## **1968 Corvette: Service Bulletin: Refrigerant** Leak

Subject: Refrigerant Leak
Model and Year: 1968 Vehicles with Air Conditioning
Source: Chevrolet Dealer Service Technical Bulletin
Bulletin No: 68-T-56
Section: Ia
Date: July 12, 1968

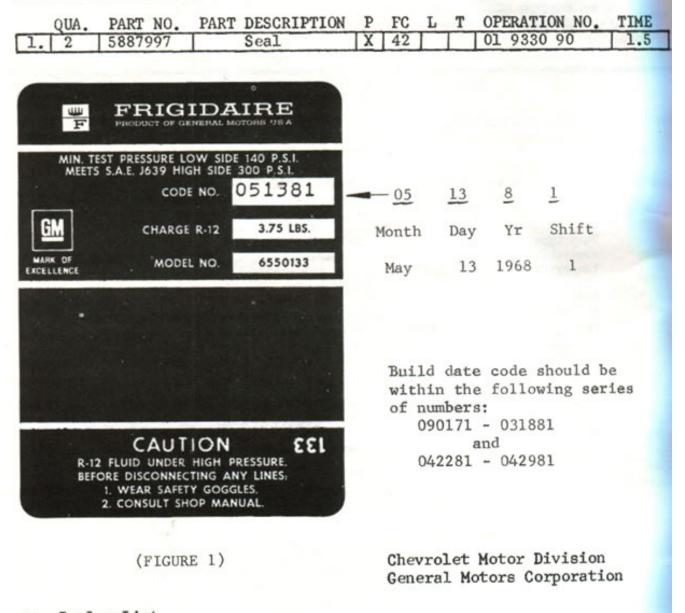
In production, the suspected seals were used between September 1, 1967 and March 18, 1968 and again between April 22, 1968 and April 29, 1968. Compressors built within these dates may be identified by noting the date stamped on the identification tag (See Fig. 1) located on top of the compressor.

For service, when a refrigerant leak is suspected but cannot be detected on compressors built within the above dates, the compressor suction and discharge seals located at the rear connector block of the compressor should be changed using the following procedure: NOTE: In addition and in order to prevent possible inconvenience to customers, it is suggested that all 1968 air conditioned vehicles that come in for service be checked to see if the compressor build date is within the above specified dates. On those vehicles with compressors within these dates view the state of charge in the sight glass and repair as necessary any that indicate low charge.

1. Discharge the system and remove the connector block from the rear of the compressor.

- 2. Remove two (2) O-rings from exposed cavities and discard.
- 3. Install new O-rings, Part No. 5887997, and reverse Steps 1 and 2.

Note: All new O-ring packages will be date stamped as of May 1, 1968. Any other O-ring should not be used. O-rings should be dipped in clean Frigidaire 525 viscosity refrigerant oil and immediately placed in suction-discharge port cavities. Do not drain or wipe excess oil from O-ring.

4. Add a dab of white paint after the shift digit on identification tag.
